TORONTO STAFF REPORT

Subject: Final Report
Rezoning Application 03 172936 NNY 07 OZ to Lift (H)
Applicant: Allan Leibel, Goodmans LLP
Architect: Page and Steele Architects Planners
3415 Weston Road and 2345 Finch Avenue West (Phase I- part of 3415 Weston Road)
Ward 7 - York West

**Attachment 5: Development Engineering,
Technical Services comments (October 27, 2005)**

SUBJECT: Site Plan Application No.: 03 172936 NNY 07 OZ, 'H' PROVISION
Your Memorandum Dated: AUGUST 30, 2005
Applicant: MEDALLION PROPERTIES INC.
Location: 2345 FINCH AVE. W., Ward: 07

Attachment 1: Site Plan

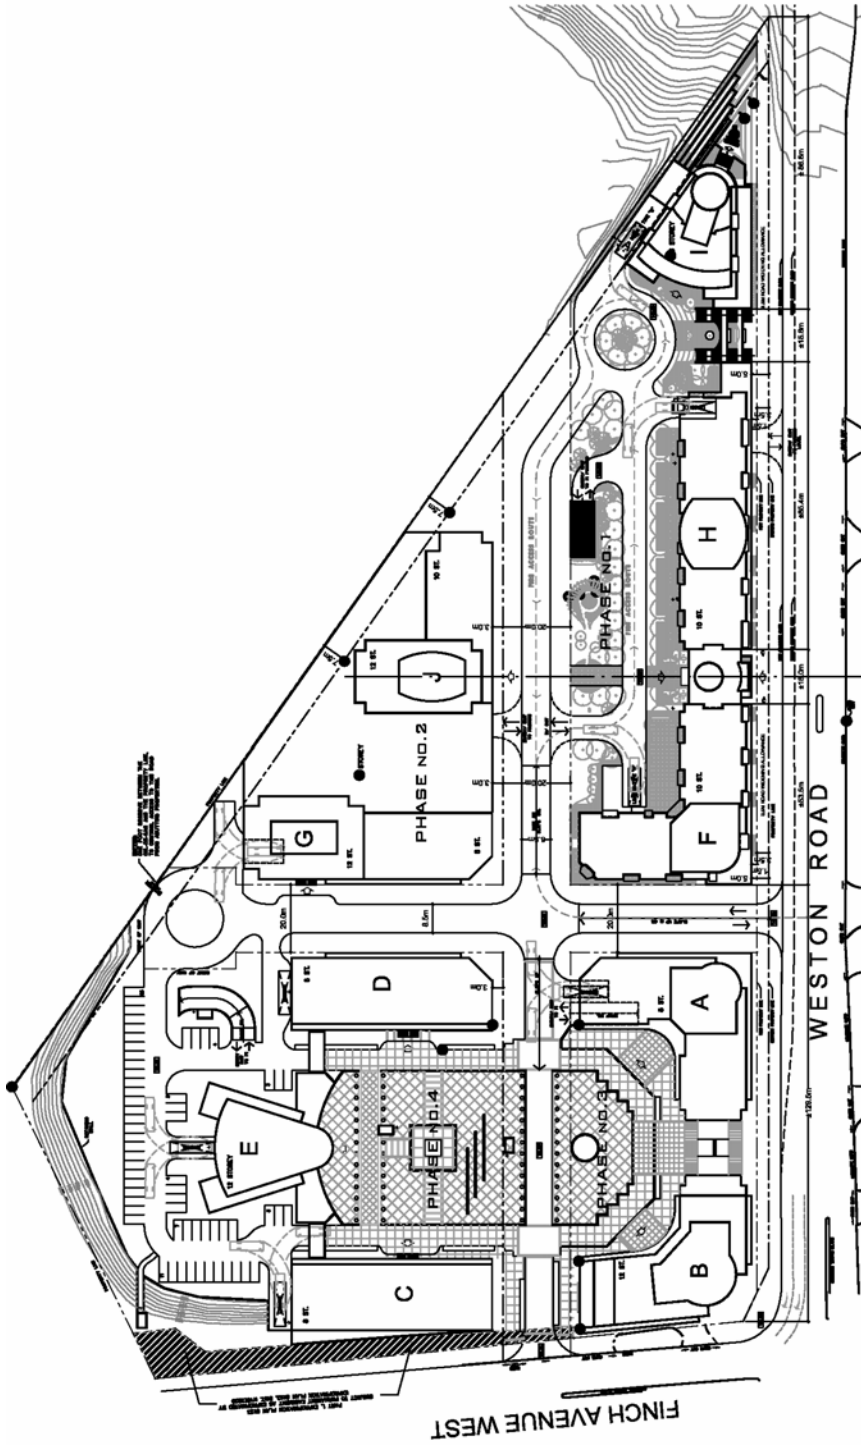
The Applicant's revised site plan illustrates the proposed east-west road situated approximately 140m south of Finch Avenue West, extending east through the subject site from Weston Road to the east limit of the property adjoining the CPR corridor. As previously described, the developer now proposes to introduce a north-south 20m public street extending south Finch Avenue West, intersecting with the future east-west 20m public road and terminating at the south limit of the

Three driveways will provide vehicle access to the subject development: two proposed full-movement access connections to Weston Road; and one existing left-in right-in/right-out access connection to Finch Avenue West.

The submitted plans illustrate a total of 452 parking stalls in the proposed two-level underground garage. The developer proposes to provide 213 surface parking stalls on the existing parking lot adjoining the vacant commercial building situated on the north side of the proposed east-west road.

The Applicant is required to convey the east-west and the north-south roads to the City. The Applicant and their successors or assigns must also provide the municipality with 5.0m x 5.0m grade level exclusive use easements at each corner of the intersection of the east-west and north-south rights-of-way.
